**TO:** All Potential Respondents  
RFB 2013 Palm River Restoration Phase II East McKay Bay

**SUBJECT:** Response to Questions

**PALM RIVER RESTORATION (W367)**  
**EAST Mc KAY BAY STORMWATER AND HABITAT**  
**RESTORATION SITES**  
 FOR  
**SOUTHWEST FLORIDA WATER MANAGEMENT DISTRICT**

**DRAINAGE STRUCTURE S200 STRUCTURAL DETAILS**

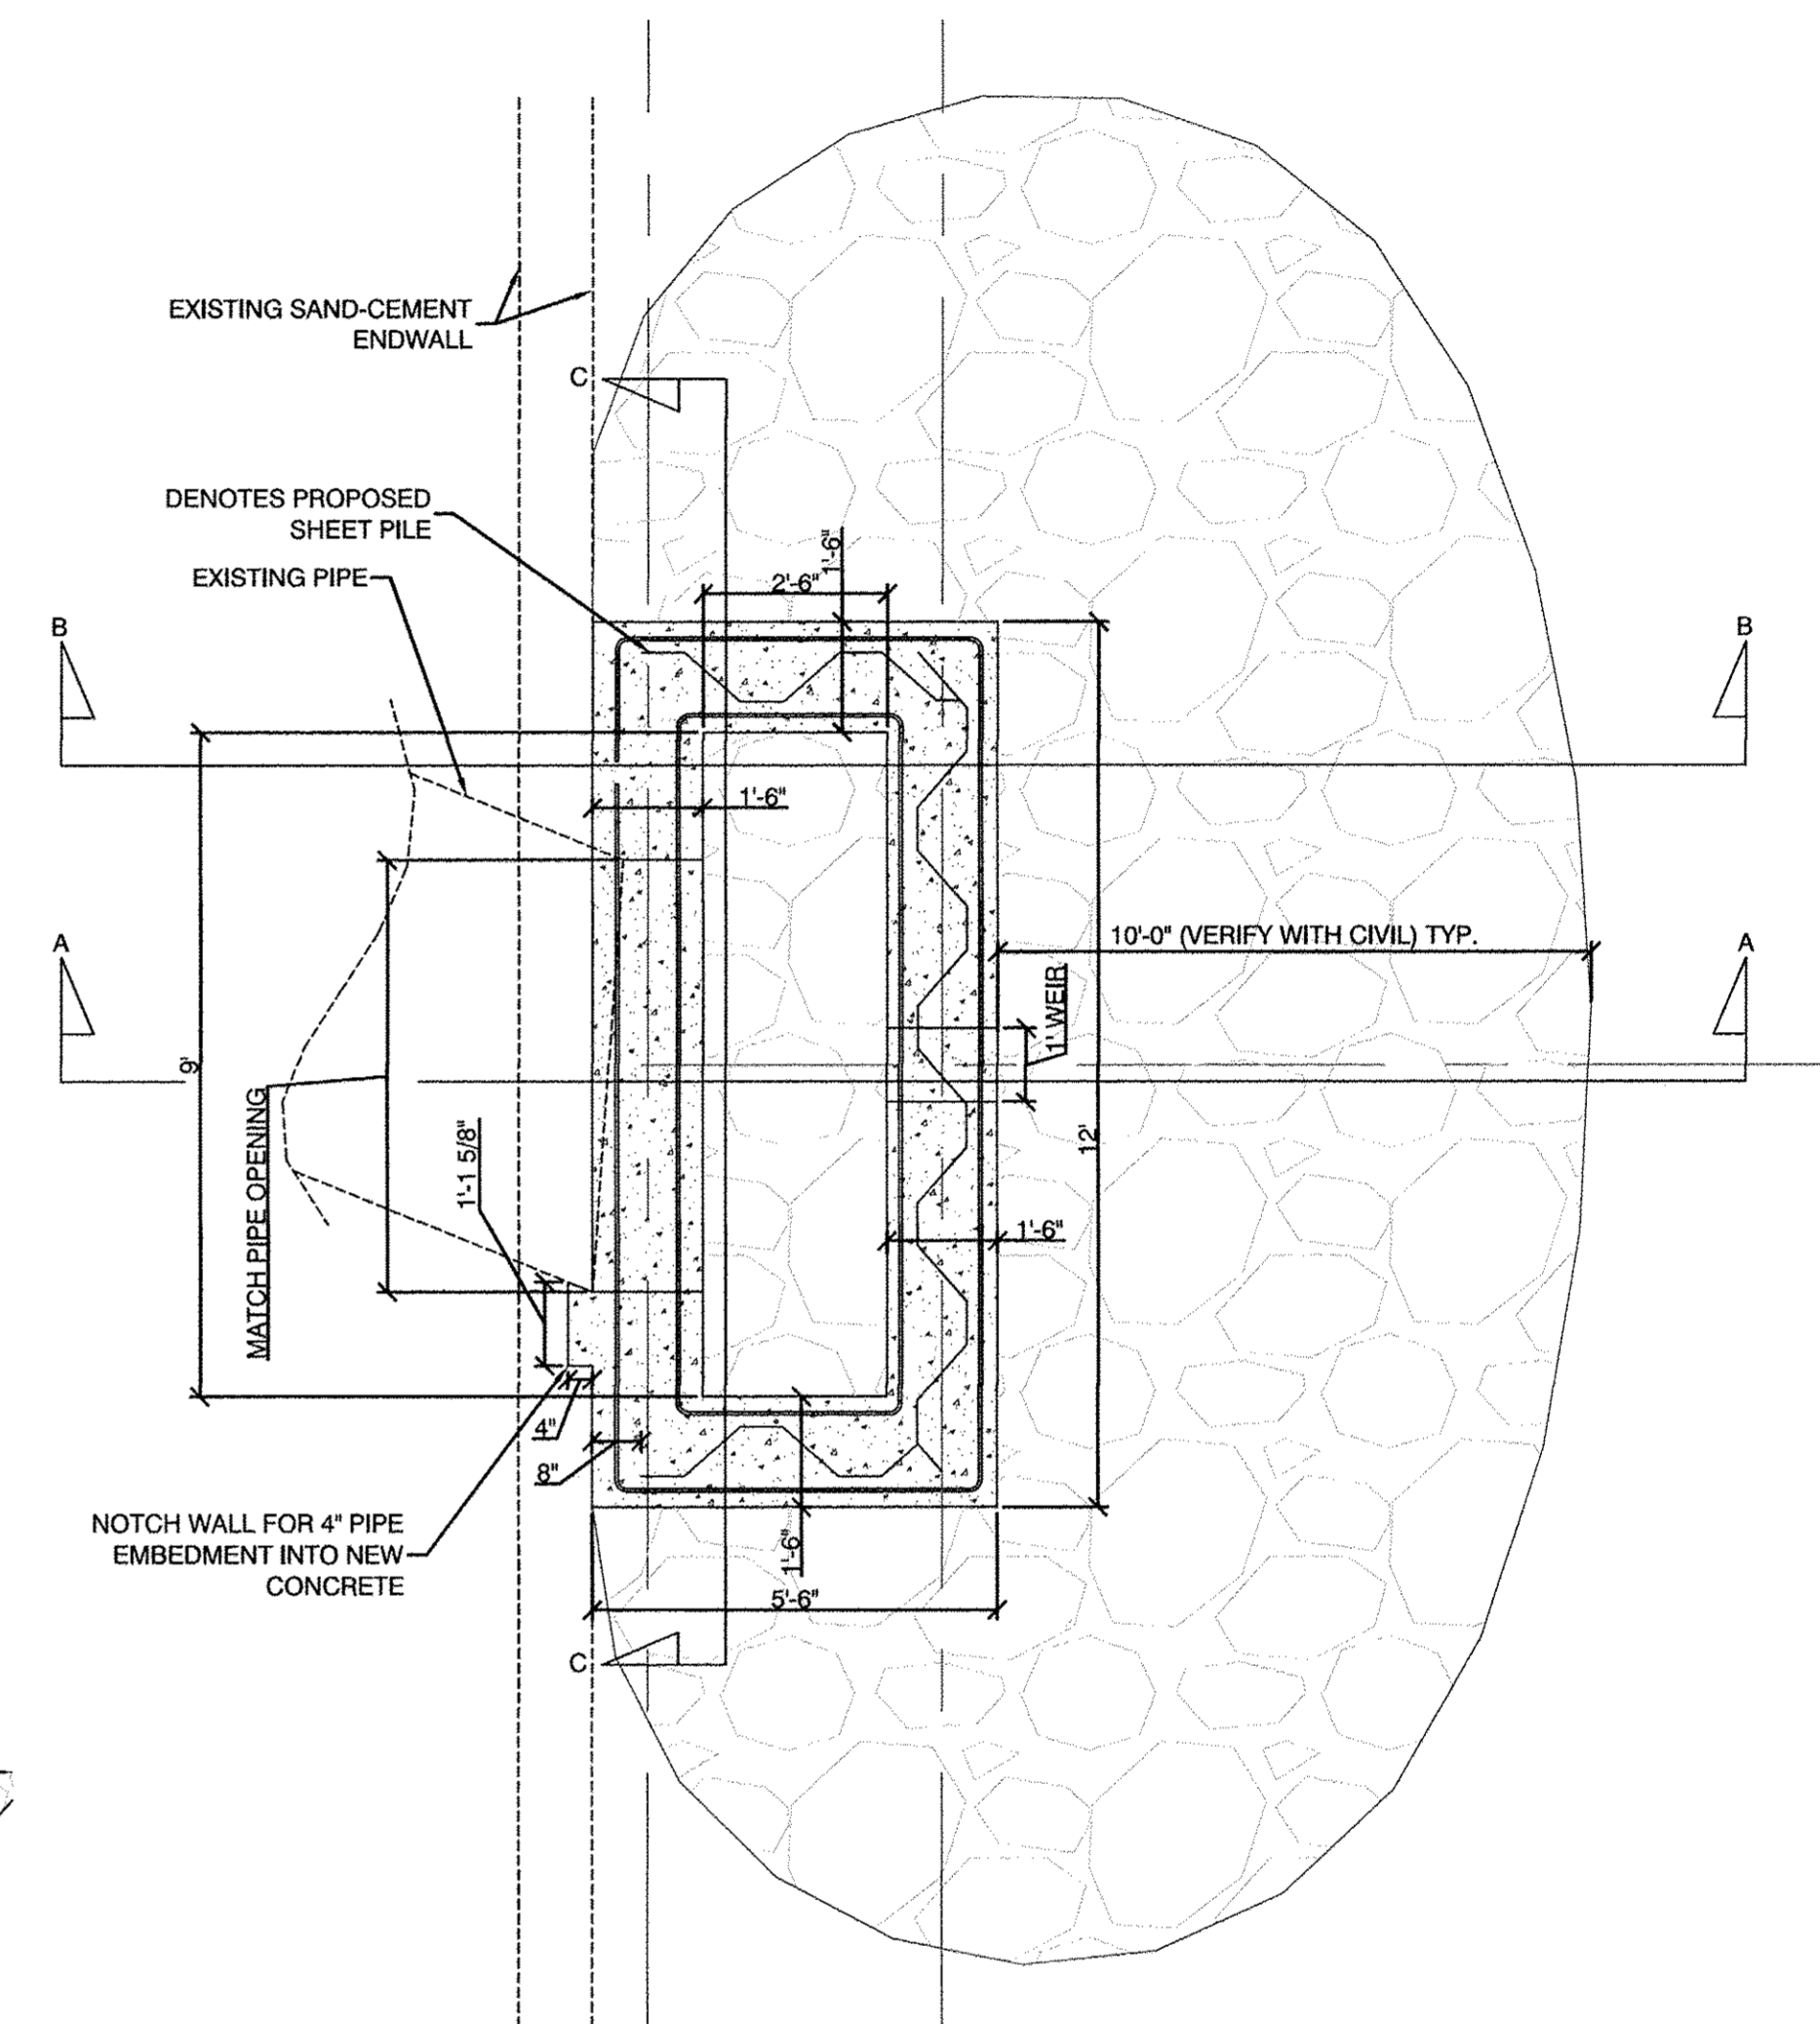
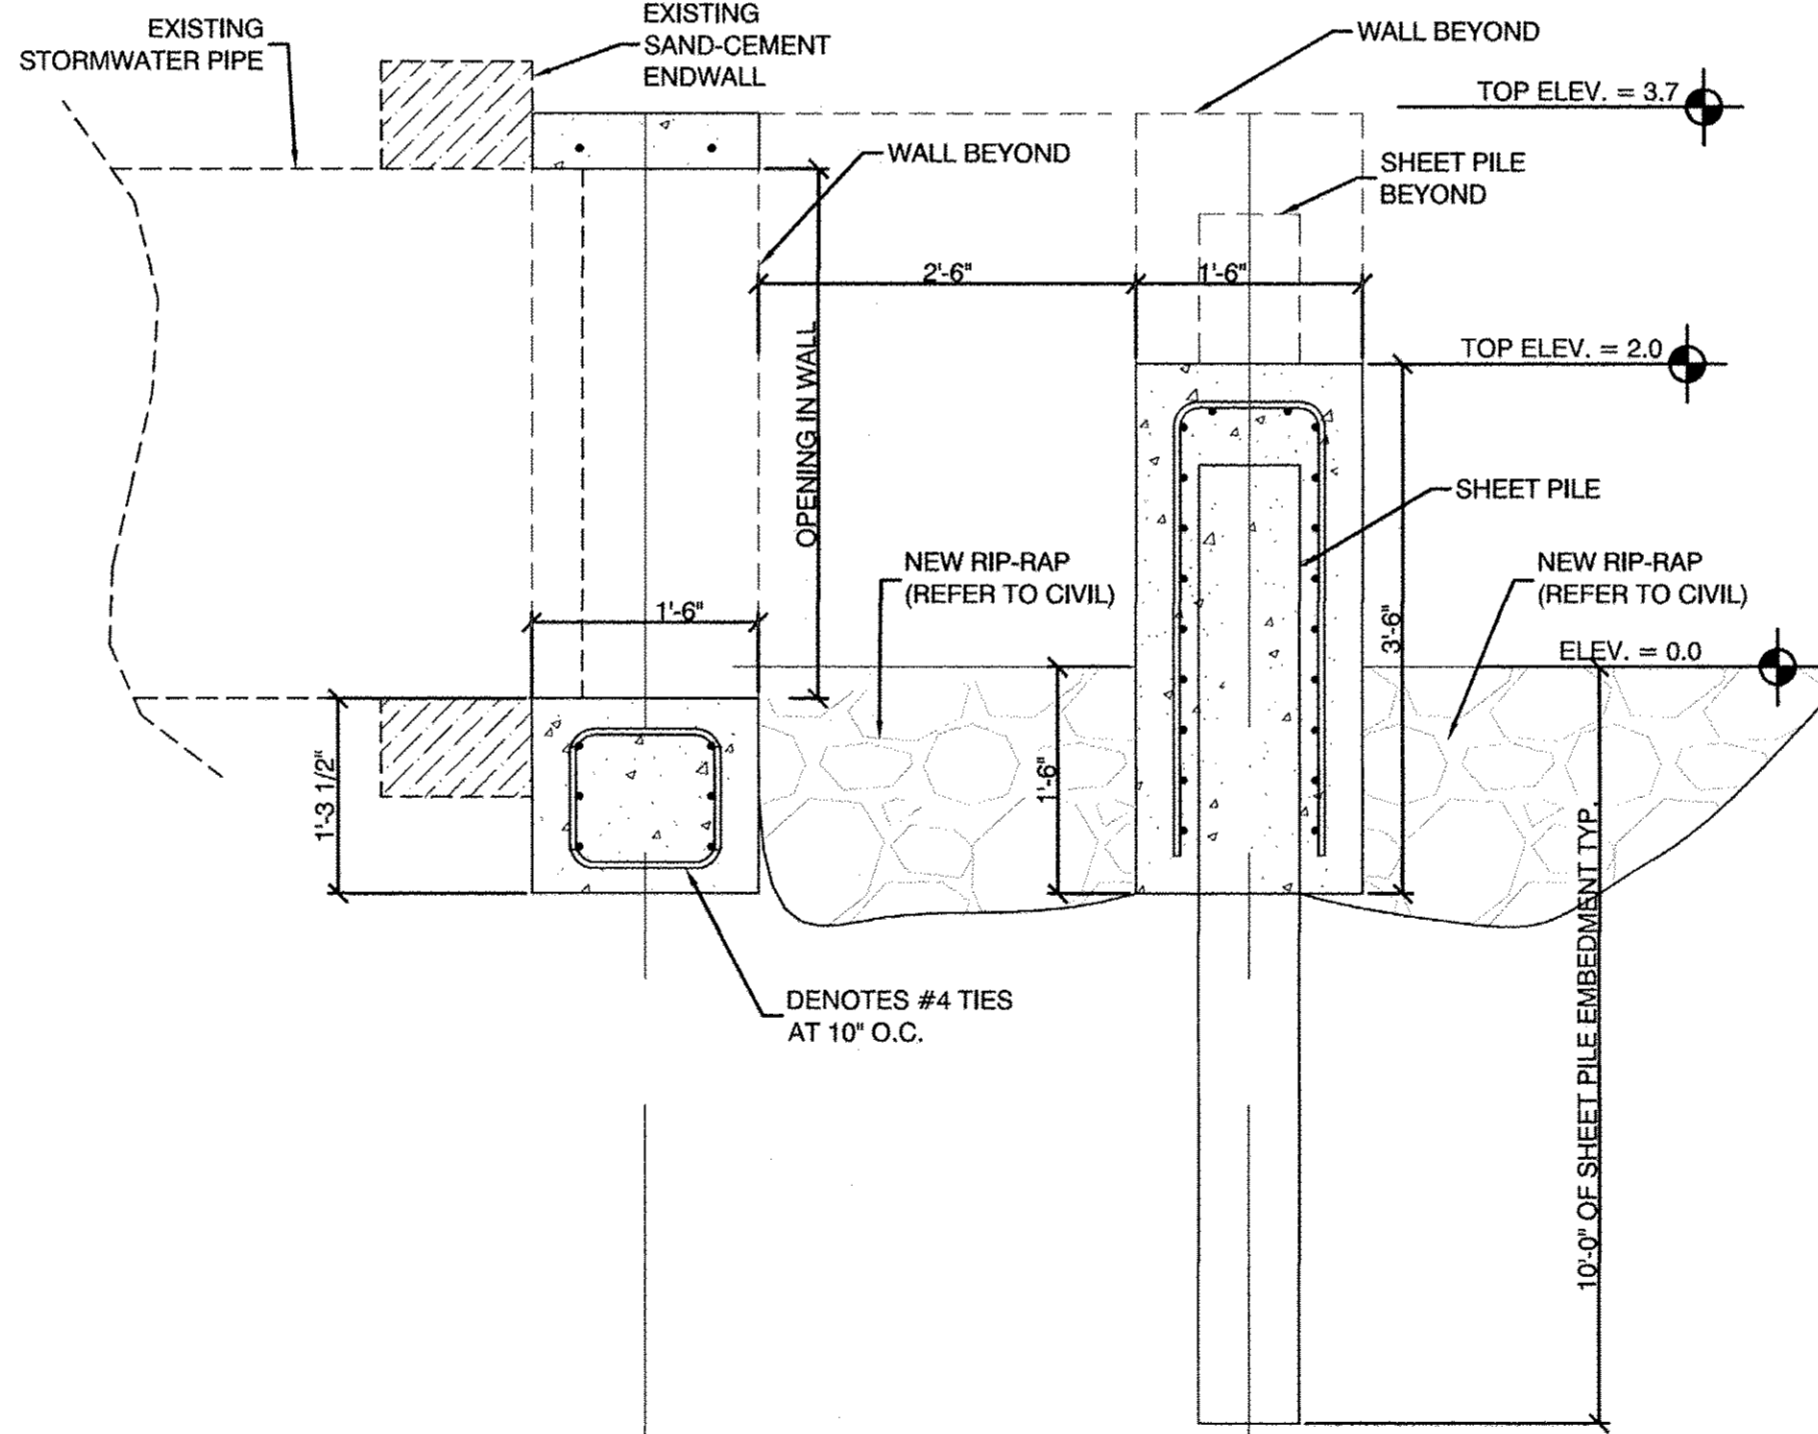
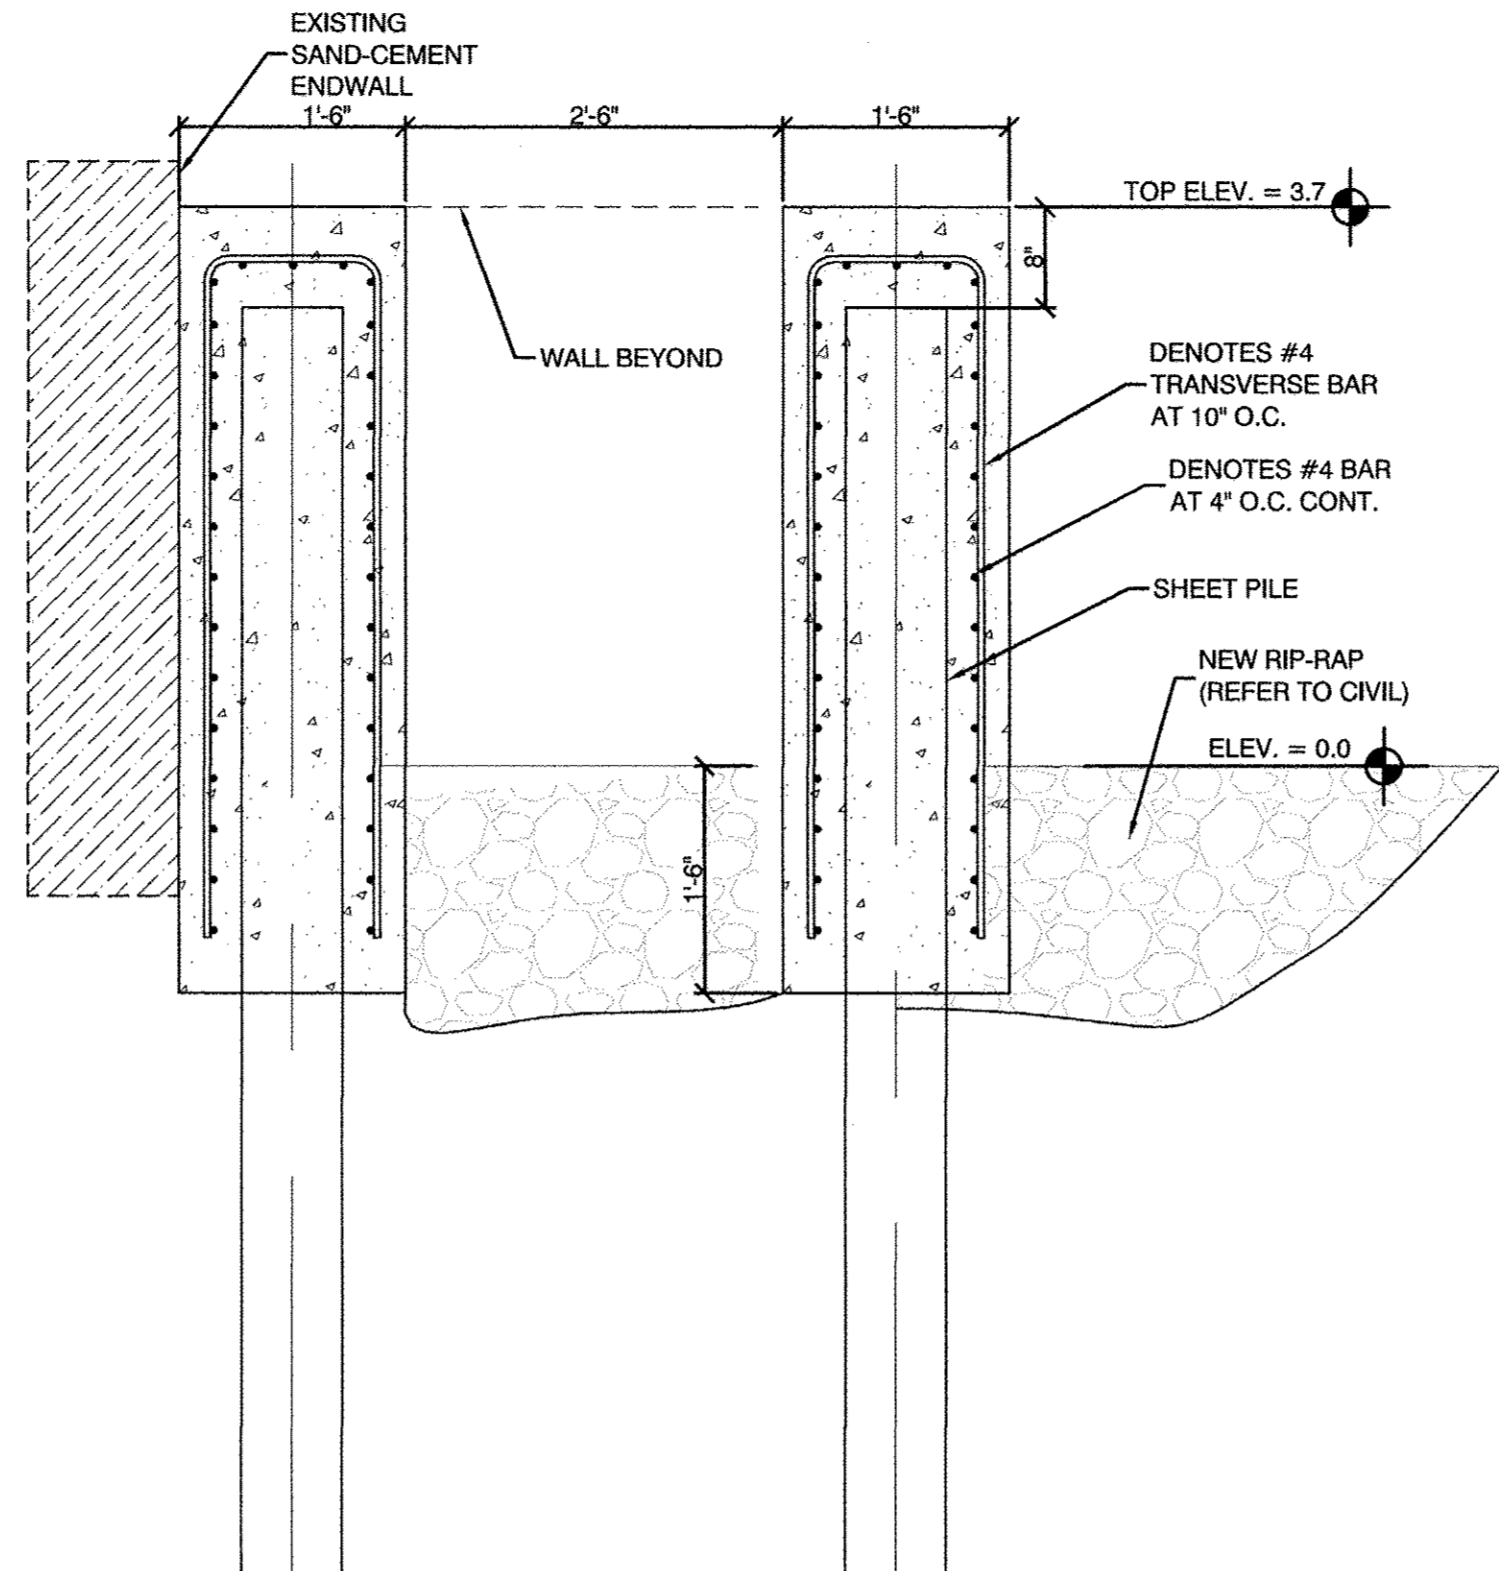
**QUESTION:** Please provide the Structural Plans for Weir Structure S200 as referenced on plan sheet 33.

**ANSWER:** Please see the attached Structural Plans (2 pages).
